Docket No. 50-346

March 29, 1985

PLANNED MODIFICATION TO THE
HIGH PRESSURE INJECTION SYSTEM

PLANNED CONFIGURATION FOR HPI PIPING INSIDE CONTAINMENT

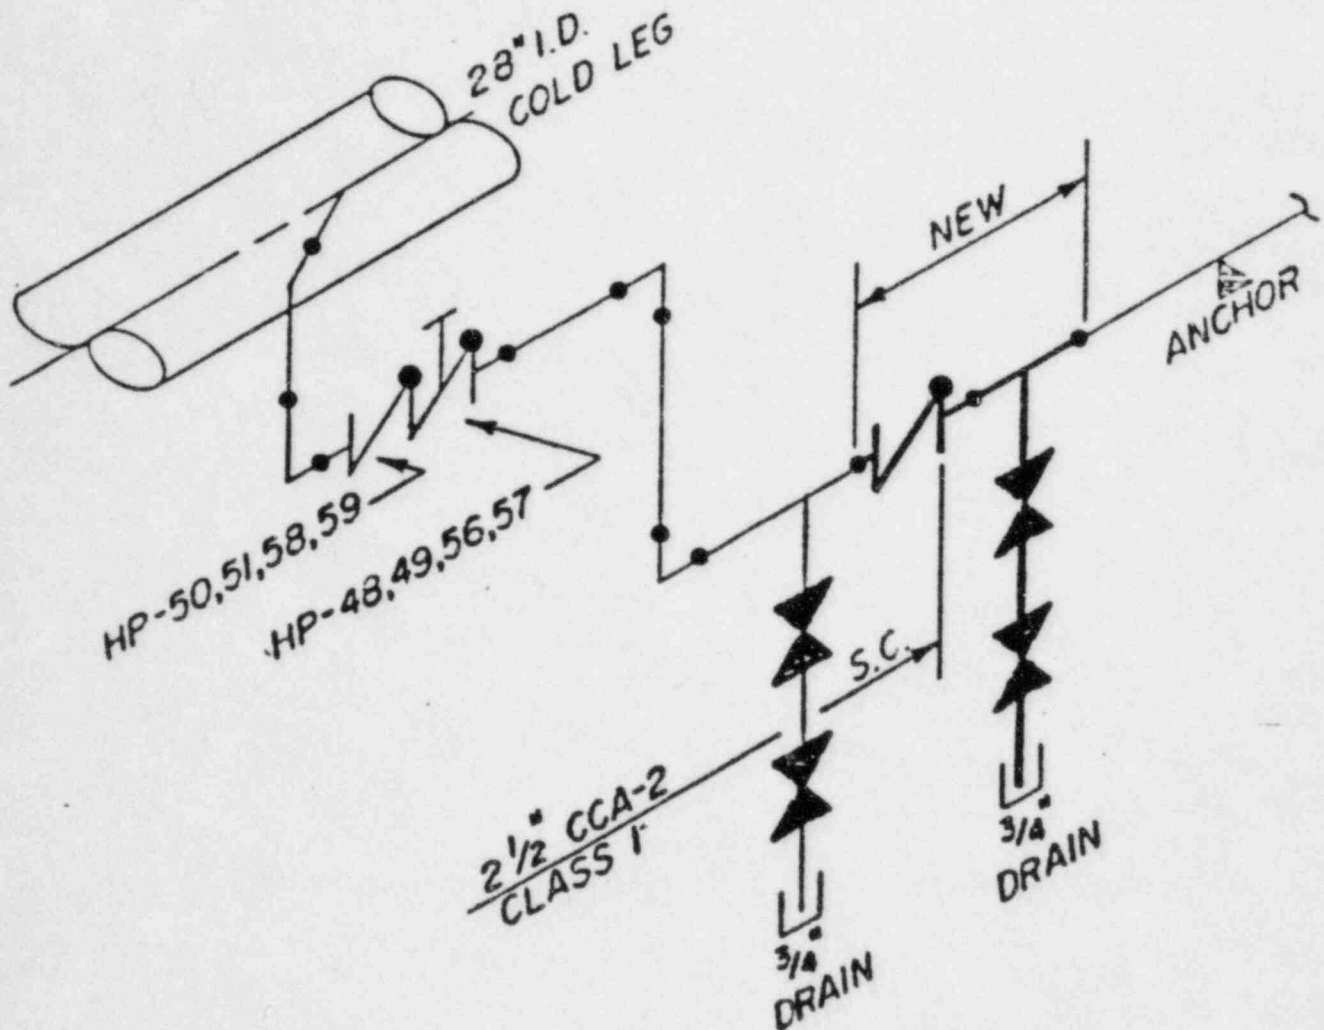
The system change includes adding a separate swing check valve upstream of the present back-to-back check valves with its own drain point available for leak monitoring. This configuration offers the following advantages to Toledo Edison:

1. Allows leak testing to be completed for the back-to-back check valves and the swing check valve on each line. The back-to-back check valves are presently considered one valve.
2. Maintains two valves in Class 1 piping as the reactor coolant system boundary.
3. Places the swing check valve upstream of the stop check valves (HP-48, 49, 56, 57), thereby separating the swing check valve from the reactor coolant system when the stop check valve is locked closed and a drain valve is opened. This will provide Station personnel the capability of maintaining the swing check valve without removing the reactor core and inserting reactor coolant system cold leg plugs during an outage.
4. Moves the swing check valve from adjacent to the reactor coolant system and cold legs, thereby changing radiation exposure to ALARA.

On a refueling outage frequency the valves will be tested for closure capability using leak detection methods to determine closure capability in accordance with Technical Specification 3.4.6.2.
